MIAMI-DADE COUNTY
DEPARTMENT OF TRANSPORTATION AND PUBLIC WORKS (DTPW)

ADDENDUM No. 5
November 22, 2024

PROJECT: Biscayne Shores Pump Station Retrofit Nos. 109 and 110 and MIC Stormwater Pump Station Trash Rack Repair
Project No. 20230197-R

CHANGES TO ENGINEERING DRAWINGS:

TRASH INTERCEPTOR

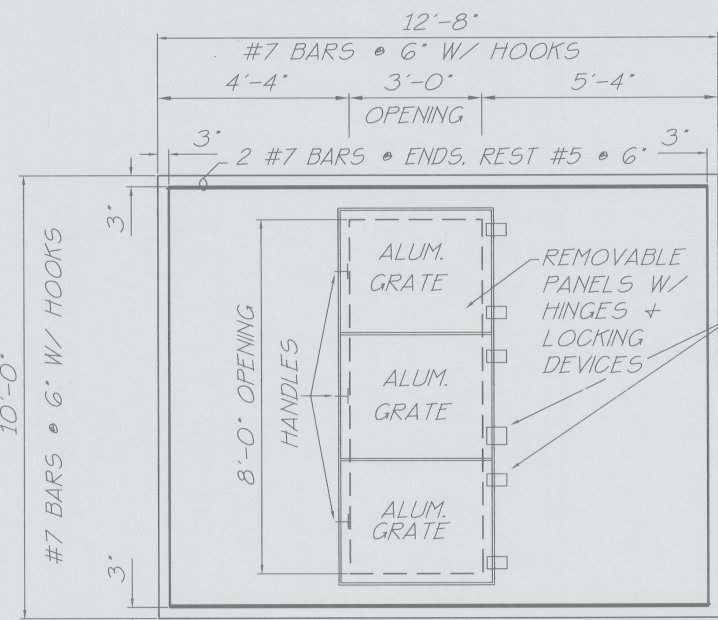
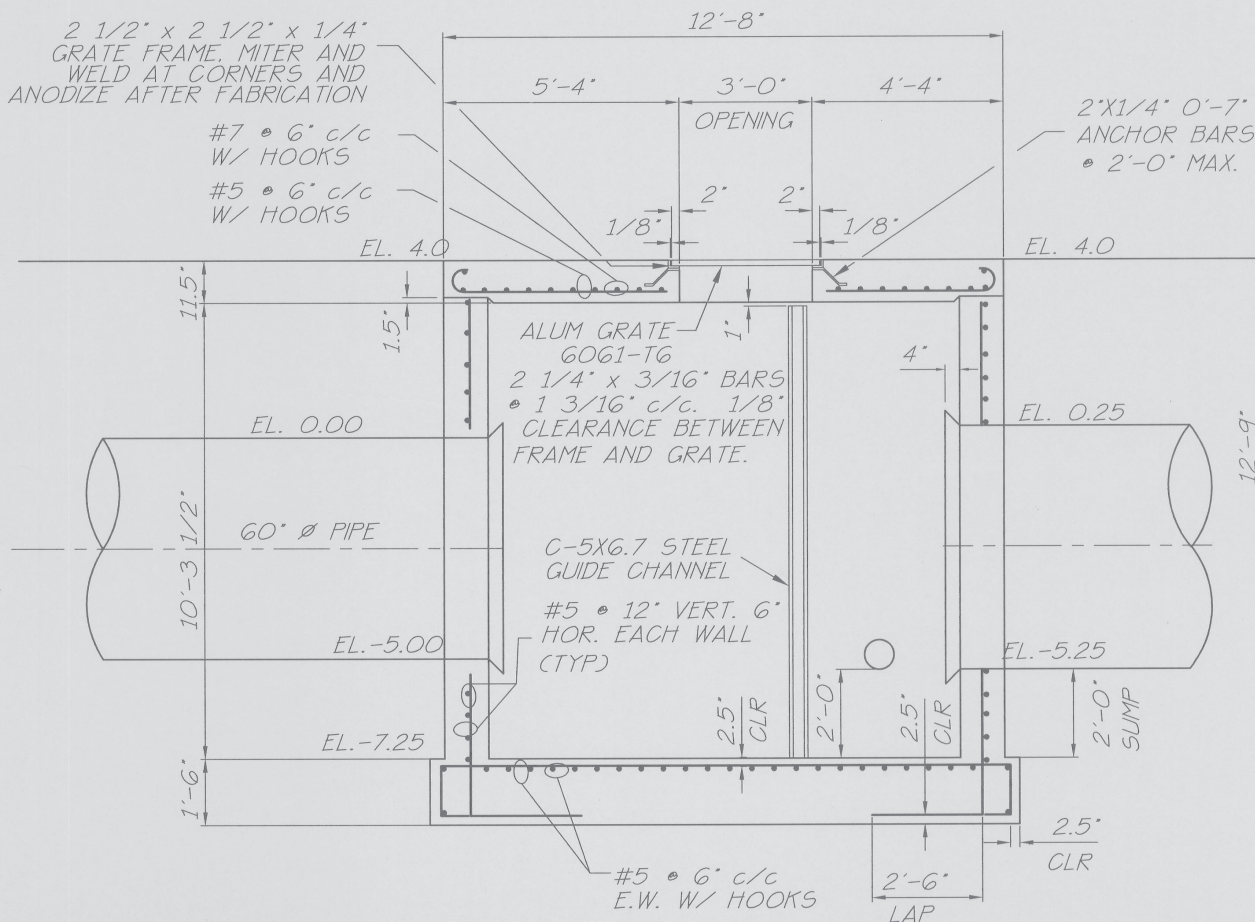
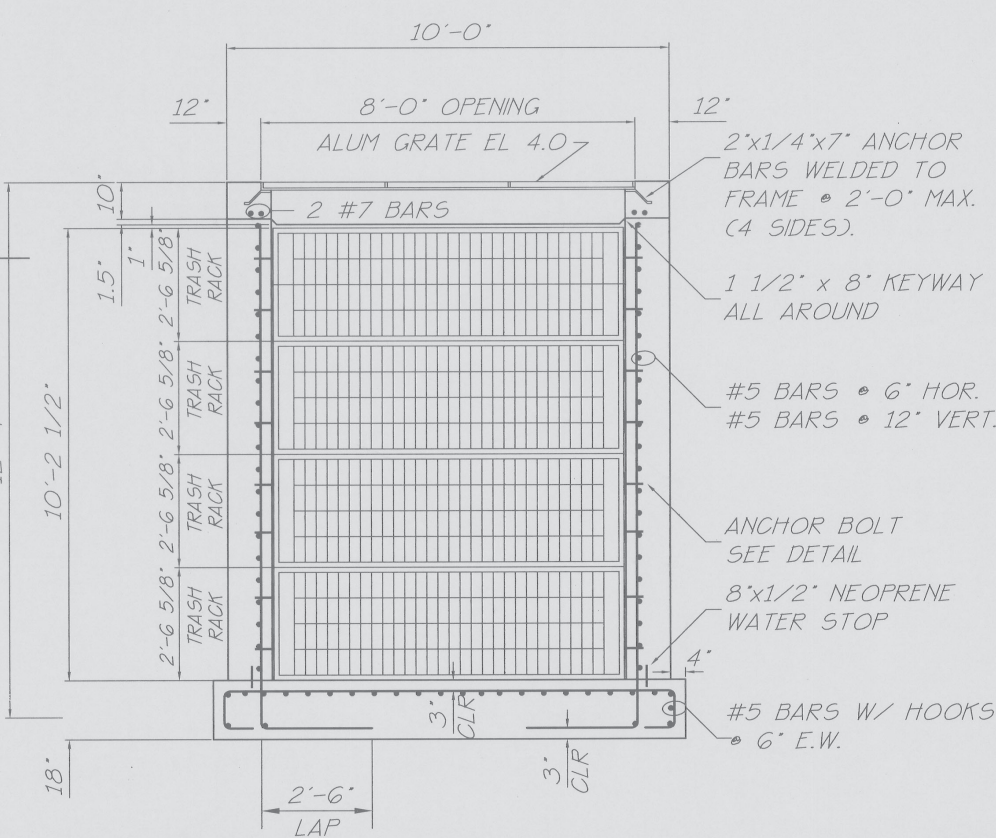
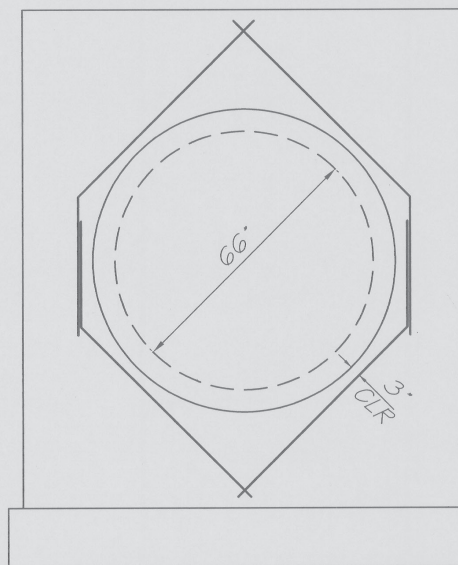
- A. Add to the Plans at NW 25 ST: Sheet No. P-7 (attached), Biscayne Shores – Phase II & Phase III, Stormwater Improvements Plans, Trash Interceptor Details.
- B. Delete 20230197 Plans PS 109 & 110 and replace them with the attached revised 20230197-R Plans PS 109 & 110 by Addendum No. 5.
